METROPOLITAN GOVERNMENT OF NASHVILLE AND DAVIDSON COUNTY

STAFF RECOMMENDATION
415 North 15th Street
July 16th, 2014

Application: New construction—Detached accessory dwelling unit
District: Lockeland Springs-East End Neighborhood Conservation Zoning Overlay
Council District: 06
Map and Parcel Number: 08305043700
Applicant: Lynn Taylor
Project Lead: Melissa Baldock, melissa.baldock@nashville.gov

415 N. 15th Street
Nashville, TN 37206

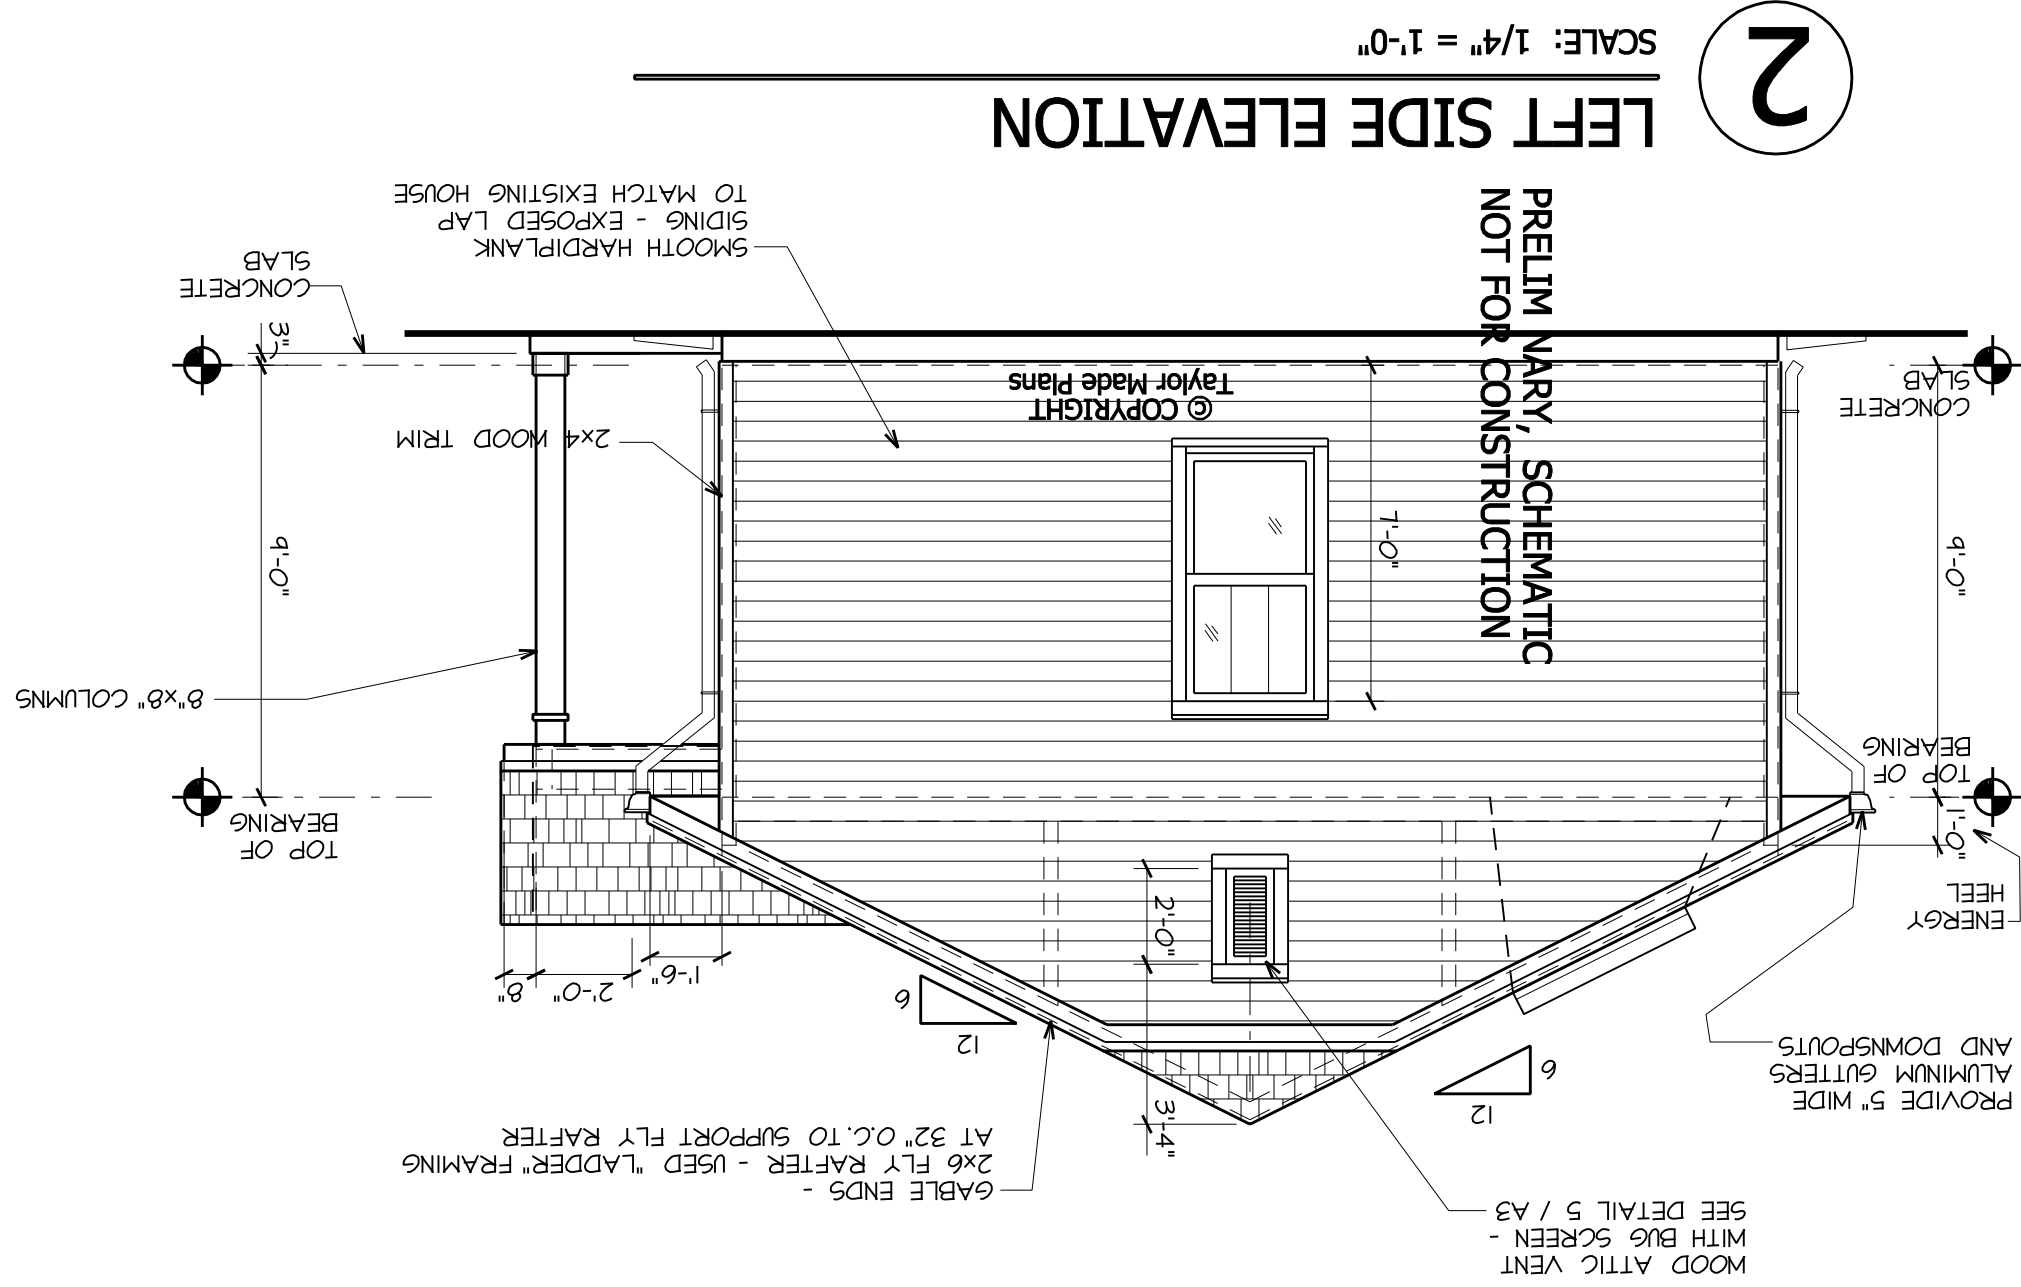
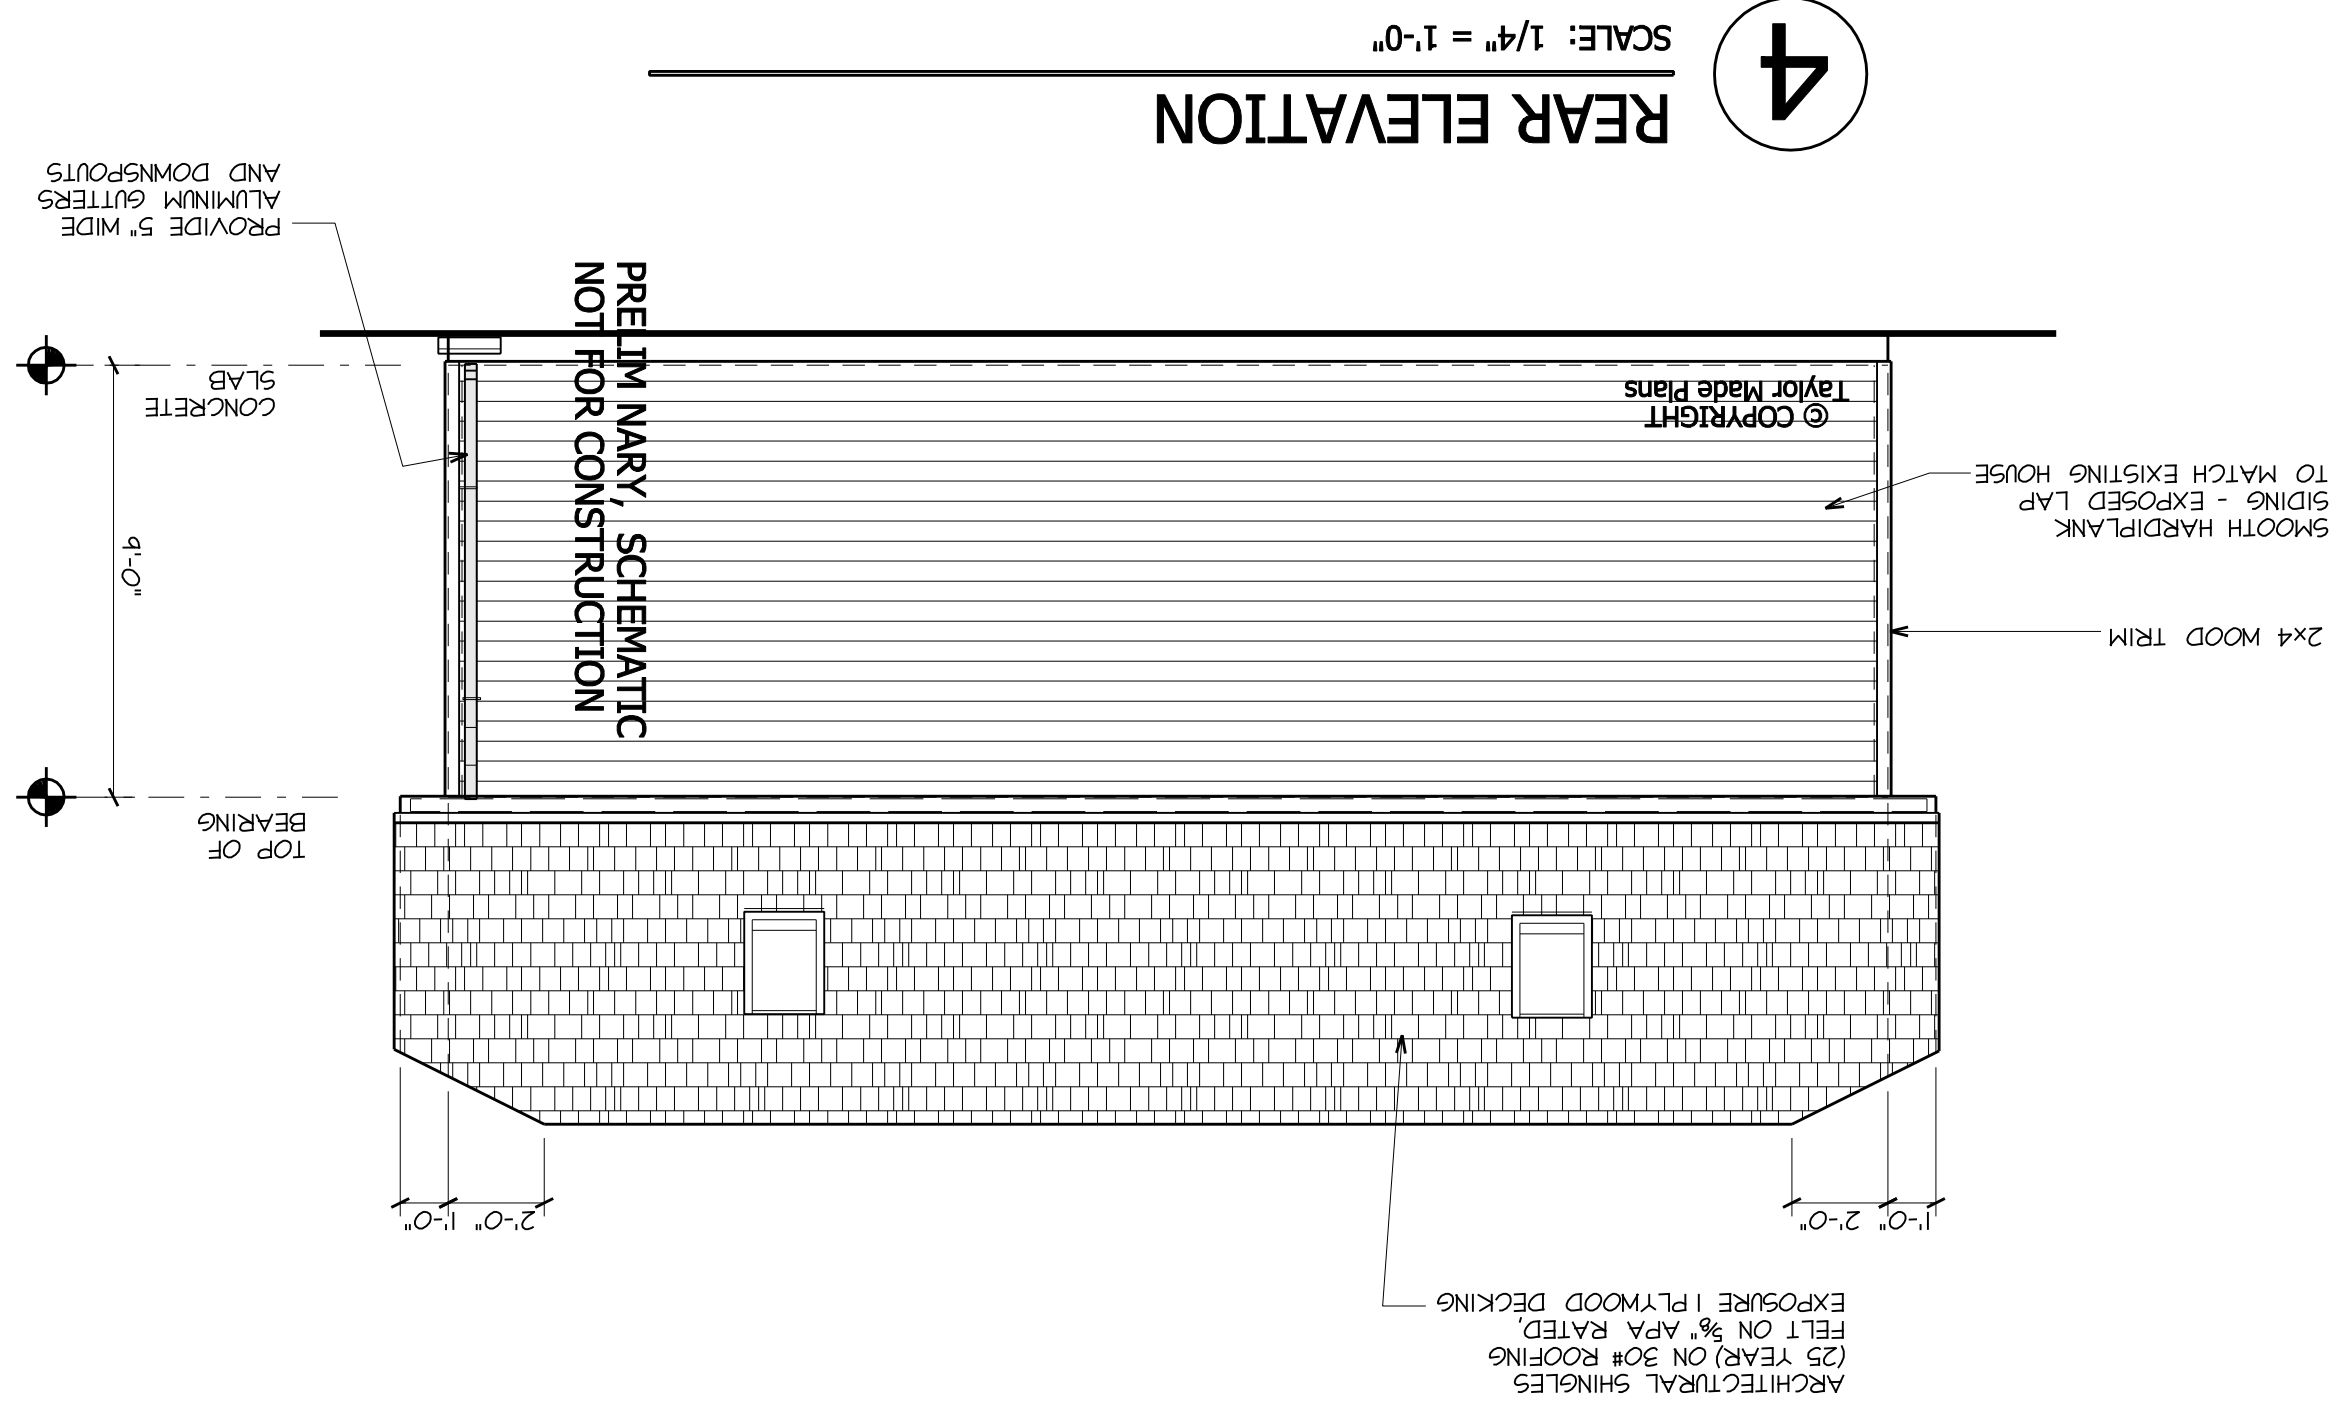
The structure's footprint is less than the maximum allowable footprint of seven hundred square feet (700 sq. ft.) for one-story DADUs, and it less than fifty-percent (50%) of the primary structure's footprint, which is over seventeen hundred square feet (1,700 sq. ft.). The DADU's eave height is approximately nine feet, six inches (9'6") and the ridge height is approximately sixteen feet, six inches (16'6"). These eave and ridge heights are subordinate to the historic house, which has an eave height of approximately eleven feet (11') and a ridge height of approximately twenty-two feet (22'), and are less than the maximums set by the DADU ordinance. The structure meets Standard 7 of the Detached Accessory Dwelling Unit regulations.

Design Standards. The DADU's design is compatible with the style of the historic structure. Its roof, detailing, and overall form do not contrast greatly with the primary structure. Because the existing structure is one-story, it does not include a stairway or dormers. The fenestration pattern is appropriate for an outbuilding. The proposed DADU therefore meet Standard 8 of the Detached Accessory Dwelling Unit regulations and II.B.8. of the design guidelines.

Materials: The DADU's foundation will be a concrete slab. The primary cladding material will be smooth-face Hardi plank with a reveal to match that of the historic house. The trim and porch will be wood. The roof will be architectural shingles, and staff asks to approve the shingle color. The materials for the windows and doors were not mentioned, and staff asks to approve all window and door specifications prior to purchase and installation. With the aforementioned staff approvals, staff finds that the materials meet section II.B.8. of the design guidelines.

Roof form: The proposed DADU will have a clipped gable roof with a slope of 6/12 which is similar to the historic house's roof form. Staff finds that the DADU's roof forms meet section II.B.8. of the design guidelines.

1. The owner file a restrictive covenant for the detached accessory dwelling unit prior to issuance of permit; and,
2. Staff approve the window and door specifications and the asphalt shingle color prior to purchase and installation of these materials.
